U.S. Department
of Transportation
**Federal Highway
Administration**

Refer to: HSA-10/WZ-164

This is in response to your letter of August 11, 2003, your prior email messages, and subsequent correspondence requesting Federal Highway Administration (FHWA) acceptance of variations to your company's portable sign stands as crashworthy traffic control devices for use in work zones on the National Highway System (NHS). Accompanying your correspondence were drawings and detailed descriptions of the stands and requested modifications. You requested that we find these devices acceptable for use on the NHS under the provisions of National Cooperative Highway Research Program (NCHRP) Report 350 "Recommended Procedures for the Safety Performance Evaluation of Highway Features."

4815RKB-60 SCHEMATIC DRAWING ROLL-UP SIGN

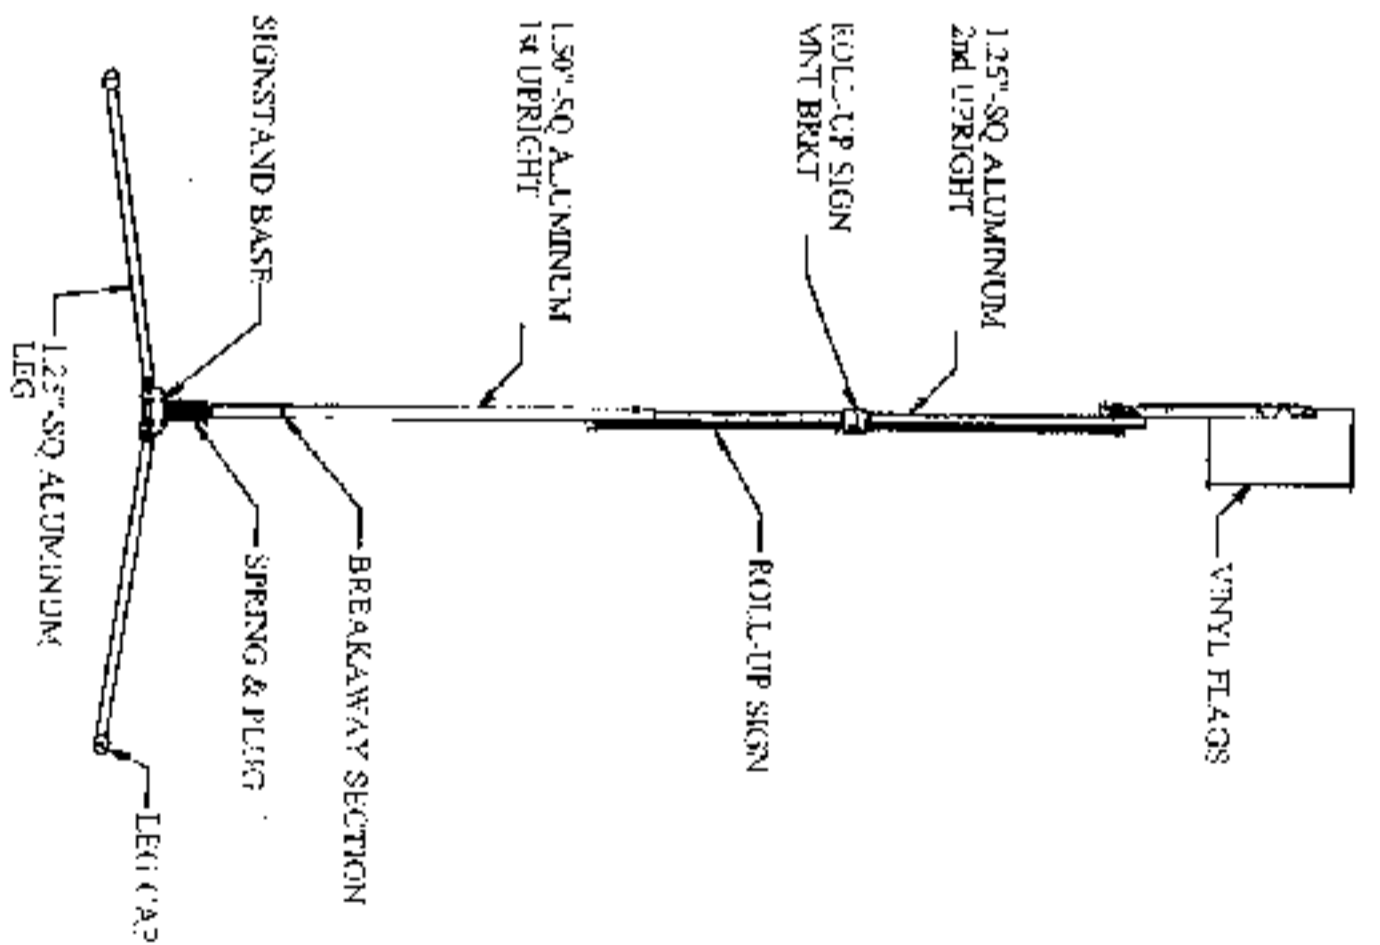
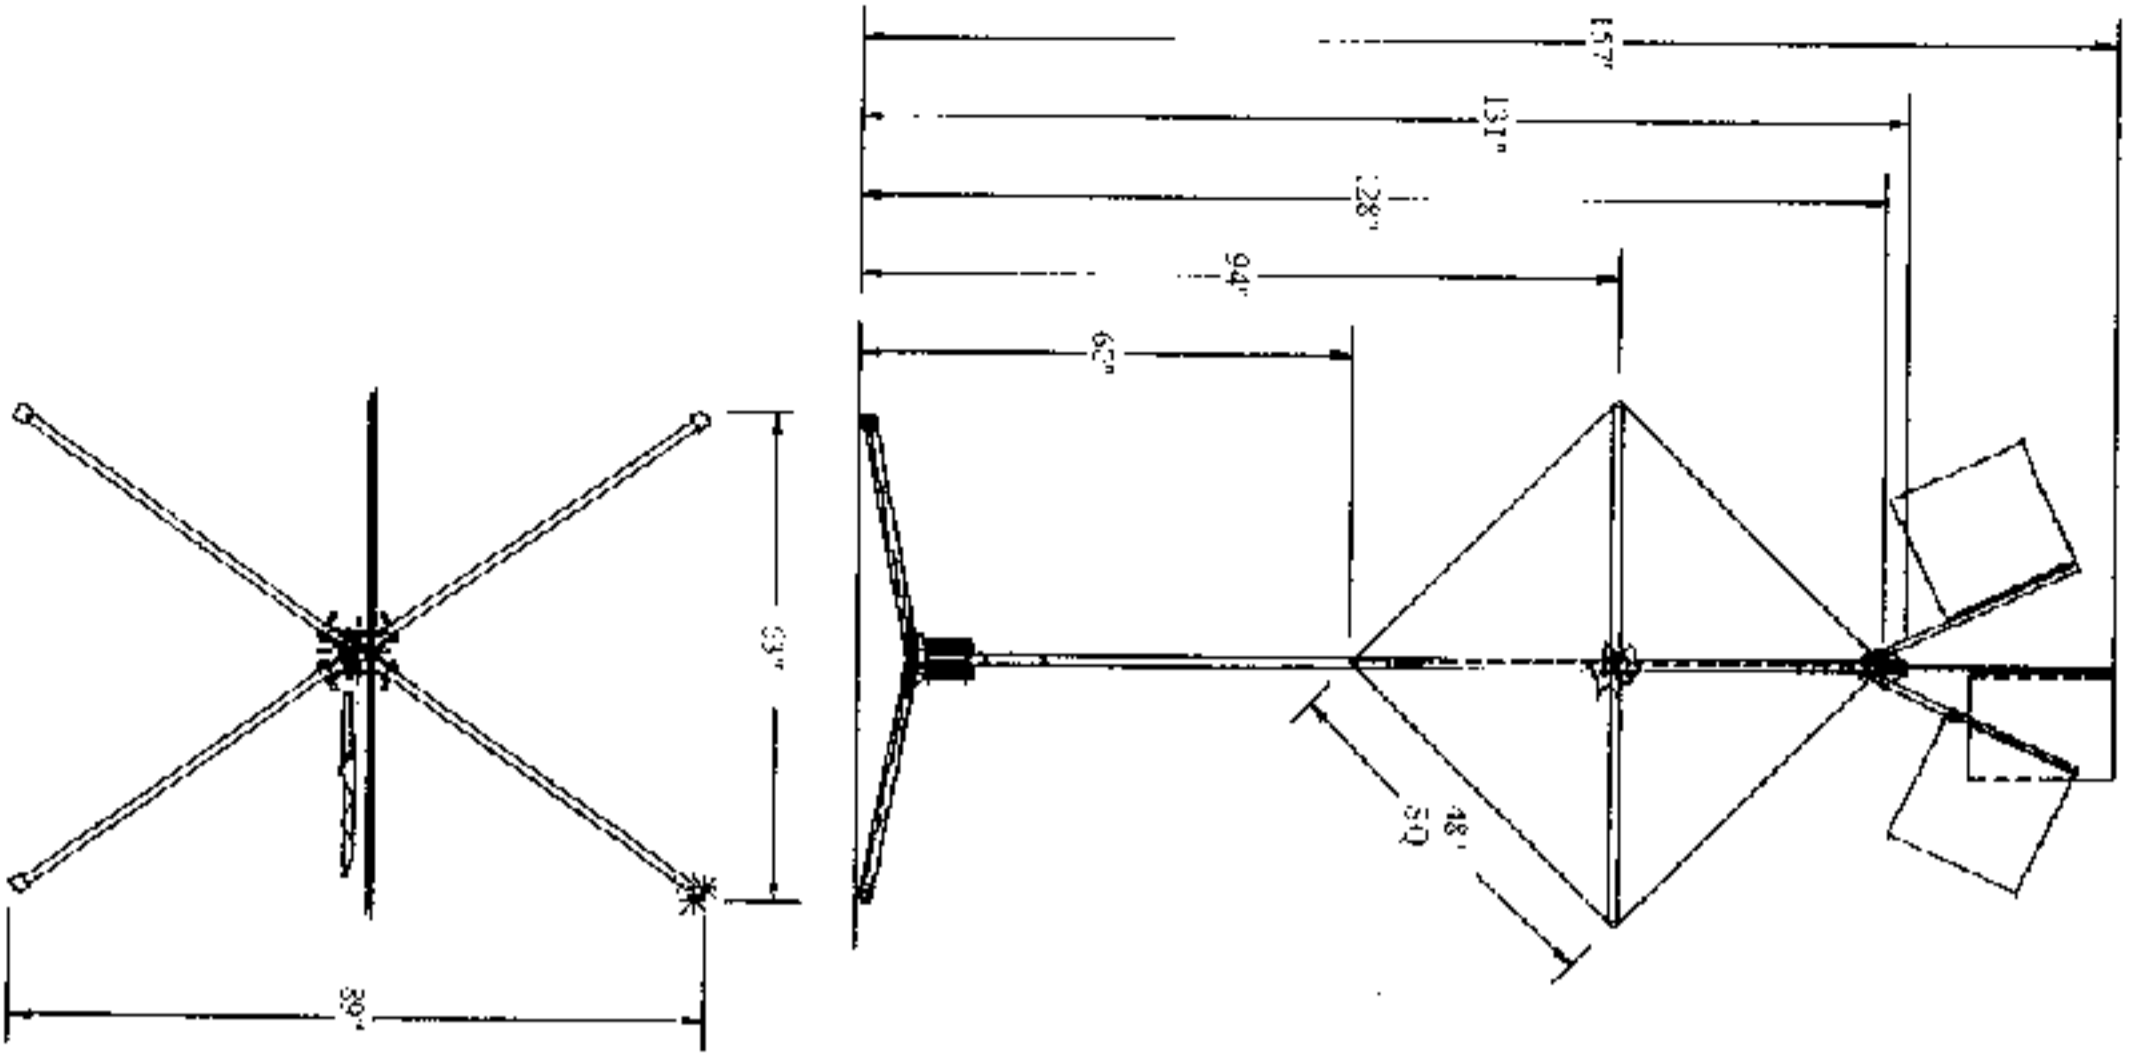
MDI Model 4815-60 stand with roll-up, aluminum laminate, and Endurance signs.

The MDI Model 4815 stand, with sign mounted at 15 inches, was found acceptable in FHWA Acceptance Letter WZ-28. The configuration of the 4815-60 uses the same telescoping base as the 4815, but uses the crash-tested breakaway mast of the Model 4860 stand (supports a sign at 60 inches height and was accepted in WZ-69). The telescoping "footprint" of the proposed 4815-60 is smaller than the tested 4860 because the lightweight signs proposed for the 4815-60 are lighter than the plywood sign tested on the 4860 stand. The performance of the breakaway mast with the lightweight signs should be comparable to the version tested with the solid aluminum sign (4860).

Full-scale automobile testing was conducted on your company's comparable sign stands, with acceptable results. Based on the analysis detailed above, the devices described above and detailed in the enclosed drawings are acceptable for use on the NHS under the range of conditions that the comparable signs were tested, when proposed by a State.
